# 320 Bren-Maur Road West

Urban Design Brief  
November 2025

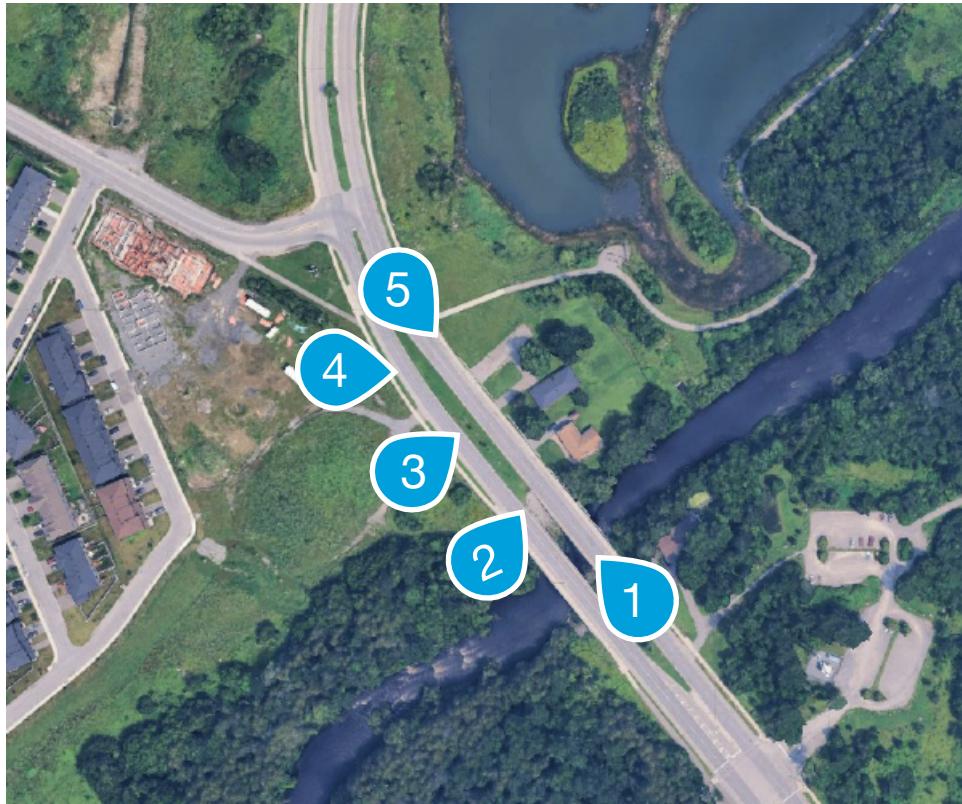
- g. Please remove the 3 parking spaces fronting Longfields to allow for additional landscaping.

**Response:** The scope of exterior parking has been reduced by 66% throughout the design process. Only 2 parking spaces for visitor parking are now proposed at grade and are located internal to the parking garage access lane, from Longfields Drive.
